Initial Project Review

Front Yard Setback Variance: Parker

Application Number: 1014284

Proposed Site Plan

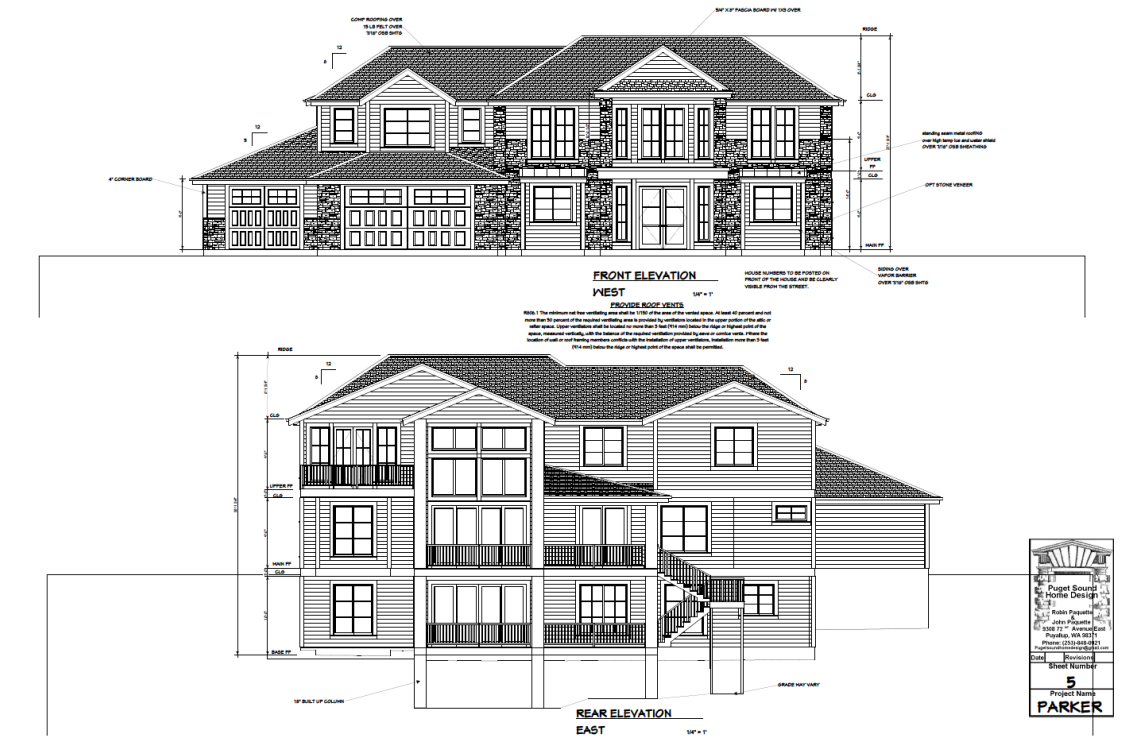
Staff Comment: The building setback mentioned above in the Applicant's Response shows the original dimension and not the actual dimension.

- Reduction of the required 25-foot front yard setback for the garage to 12.1 feet from 140th Avenue East would not allow enough depth in the driveway for a car to be parked. Parking a car in a 12.1-foot driveway would be detrimental to the public as the car would impede the sidewalk and project into the right-of-way.

- The applicant believes there is enough room along the north side of the proposed residence to allow for two parking spaces; however, the width of the setback may need to be modified as well as seeking approval from the geotechnical engineer for soil stability.

Proposed Building Elevations

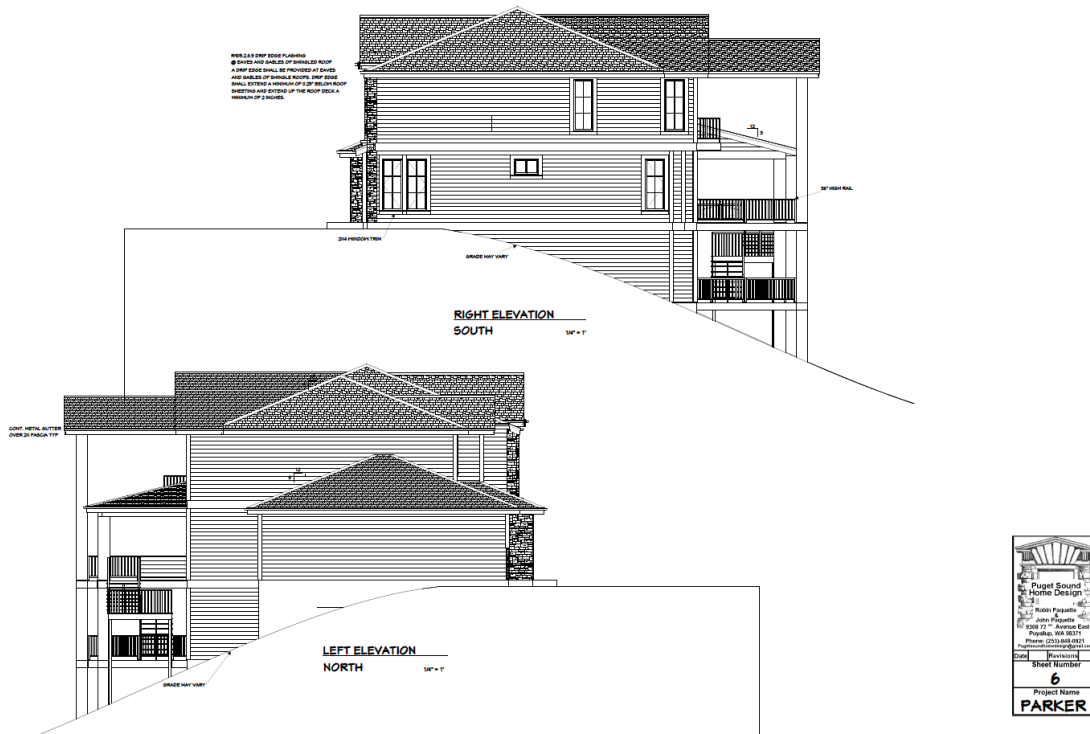
- The proposed building elevations on the east side (back side of the house) show several outside covered decks which could be reduced in size, still allow a view, and allow the home to be closer to compliance with the front yard setback.
3. The granting of such variance will not be materially detrimental to the public welfare or injurious to the property or improvement in such vicinity and zone in which the subject property is located.
